Access Compliance Report

Public Rights-of-Way (Curb Ramps)

| Intersection ID: 20800 | Main Street: HILLSTONE_CT | Cross Street: SANDY_PORTER_RD | Location: SW |
| ADA ID: FC3517156906 | Ramp Type: Directional1 | Initial Pass/Fail: Fail | Overall Compliance: No |

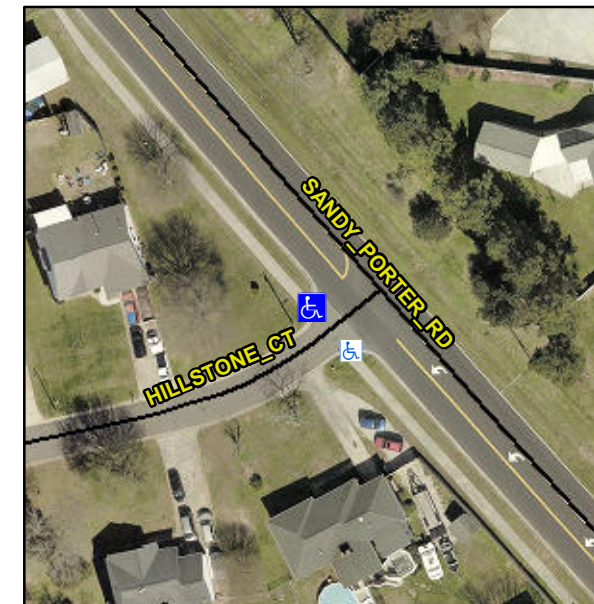
R304.5.3

| Compliance | Description | Data | Compliance | Description | Data |
|------------|-----------------------|-------|------------|-----------------------------|------|
| No | Ramp XSlope (%) | 2.6 | | | |

Remove & Replace Entire Ramp.
